UNITED STATES PATENT AND TRADEMARK OFFICE

Office Action Summary	Application No. 10/826,311	Applicant(s) STABEL ET AL.	
	Examiner Sara Addisu	Art Unit 3722

DETAILED ACTION

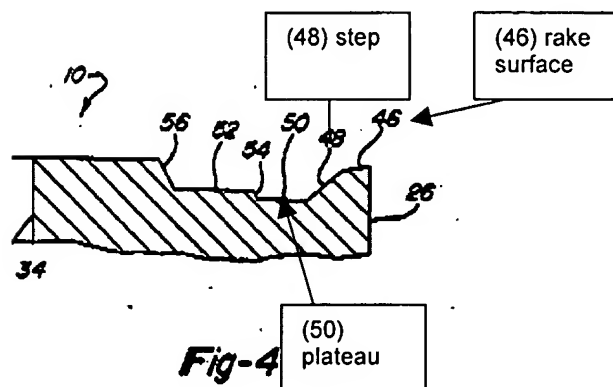
Katbi et al. teaches a cutting insert having a multi-cornered base body (square when viewed in top view, fig 2) including top and bottom surfaces (12 & 14), side flanks (26, 28, 30 & 32) interconnected by corner surfaces, cutting surface (36) on top and/or bottom surface, peripheral cutting edge (38) formed at the intersection of side flanks and top and bottom surfaces (12 & 14) (see figure 1 and Col. 2, lines 40-45). Katbi et al. also teaches the cutting surface having a central bore (34), a plateau (50 with raised support pads 52) located on the top and bottom surfaces surrounded by a peripheral positive rake surface (46) that is situated between the plateau surface and the cutting

edge (38) (see diagram below). Furthermore, Katbi et al. teaches an upwardly extending variable peripheral step (48) interconnecting the plateau (50) and the rake surface (46) (with the corner step portions extending uninterruptedly along the respective corner rake surface portions) (see figure 2, which also shows that step (48) is linear when viewed perpendicular to the cutting surface). Additionally, Katbi et al. teaches side flanks forming obtuse corners (see figure 2). Katbi et al. also teaches in figure 3, lateral cutting edge (38) having a sagging middle portion therefore the step is of varying height having a maximum height is disposed at the corner step portions and a minimum height midway between the adjacent corners (refer to the explanation and figure below regarding the varying height of the step: see argument under Response to Arguments). Regarding claim 19, Katbi et al. teaches variable width land surface (rake) which is changes width at (44) leading to a wavy step portion around the corners (see figure 2 and Col. 2, lines 49-54).

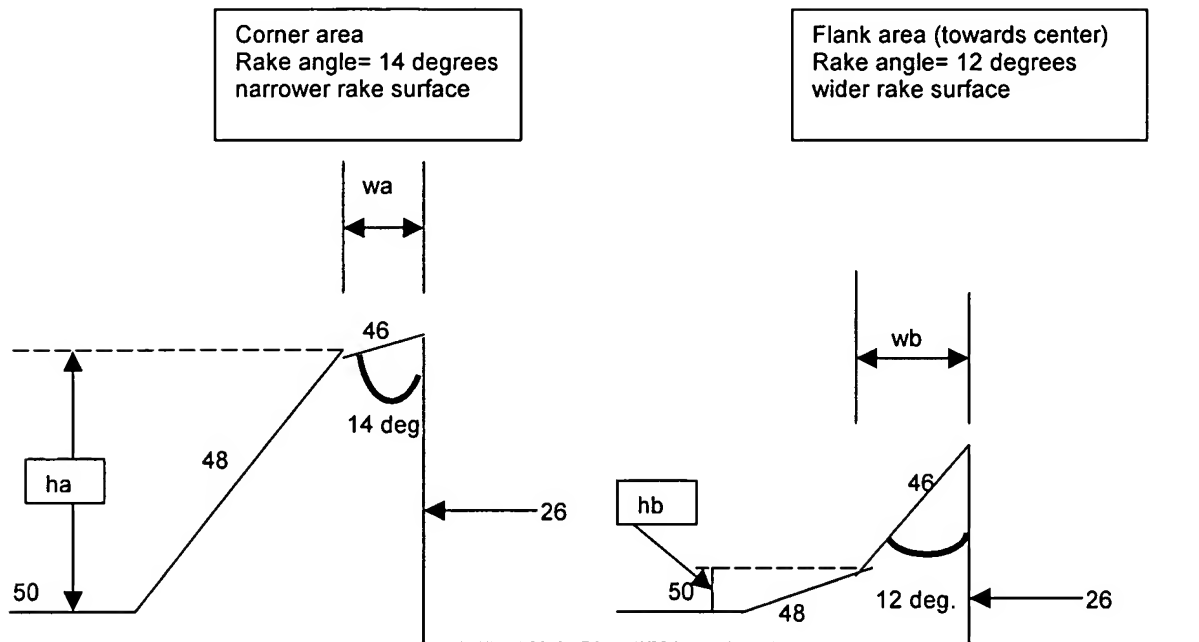
8. In response to Applicant's argument regarding claim 1 (page 8, lines 6-11) that *"As described at col. 2, lines 45-47, the cutting edge 38 is in the shape of a descending arc 40 from corner to each adjacent corner of the insert. However, irrespective of the arc shape of the cutting edge, as clearly illustrated in Fig. 1, the height of the step 48 is uniform all along the circumference of the cutting insert. There is no variation at all. The height of the step is the same at the corner of the cutting insert as well as at the middle between two corners"*, Examiner respectfully disagrees. Examiner points out that Katbi et al. teaches the cutting edge (38: which is arched) has a descending rake (46) located rearward from the cutting edge and the descending rake face is followed by a descending step (48) ('591, figure 4 and Col. 2, lines 45-58 and 66-68). If the height of the step was constant then the step would no longer be descending towards the center of the insert but rather ascending since the rake surface just forward of it has a variable descending angle. See figure below for further explanation (the angles are exaggerated). Katbi et al. teaches the rake face (46) having descending angle 14 degrees and narrower width (wa) at the corner and 12 degrees and a wider width (wb) towards the flank ('591,

Col. 2, lines 58-60 and 51-53). As shown below, the left figure indicates corner portion where the cutting edge is at it's highest height (because it's arched at the center), however the rake face has a wider descending angle and a narrower width (w_a) which leads to the following portion (i.e. descending step, 48) to start descending from a higher location to plateau 50. On the other hand, the right hand figure represents the flank area such as the center where the cutting edge is at its lowest height (because it's arched at the center), however the rake face has a smaller descending angle and a wider width (w_b) which leads to the following portion (i.e. descending step, 48) to start descending from a lower location to plateau 50, thus there is a height difference (h_a is higher than h_b) (i.e. the step has a varying height, wherein a maximum height is disposed at the corner step portions, as recited in claim 1).
